**INTERPRETATION IC 135-2020-27 OF
ANSI/ASHRAE STANDARD 135-2020 BACnet® -
A Data Communication Protocol for Building
Automation and Control Networks**

Approval Date: January 20, 2024

Reference: This request for interpretation refers to the requirements presented in ANSI/ASHRAE Standard 135-2020, Clauses AB.2.1, AB.4.2, AB.4.2.2 and Figure AB-8, regarding Destination Virtual Address.

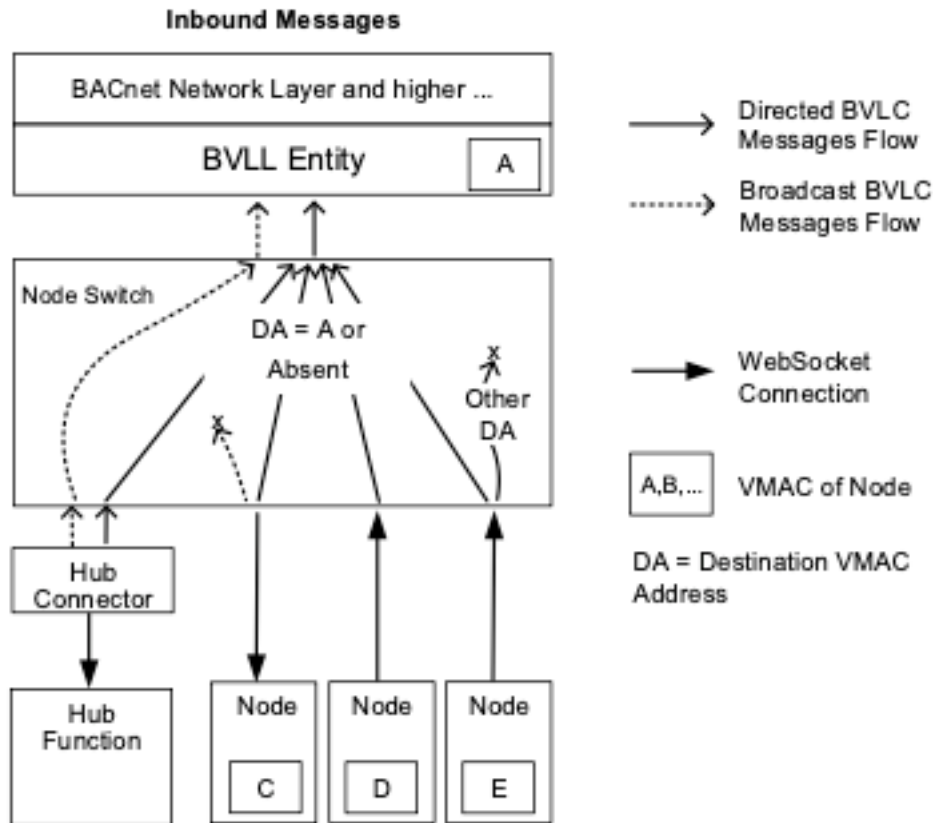
Figure AB-8 for “Inbound Messages” shows “DA = A or Absent” which **seems to imply** that DA can be present for direct connect.

- The twice-indicated mandate to omit the Destination Virtual Address is unequivocal in Clauses AB.2.1 and AB.4.2.
- The confusing text in Figure AB-8 addresses *both* the internal Hub Connector API and Direct Connect cases and is therefore *not* a permission to send Destination Virtual Address on the wire.
- The *implications* made by last two paragraphs of AB.4.2.2 contain errata that do not override the explicit *mandates* in AB.2.1 and AB.4.2

Answer: Yes

Comments: The last two paragraphs of AB.4.2.2 contain errata will be corrected. The Figure AB-8 contains errata and will also be corrected.
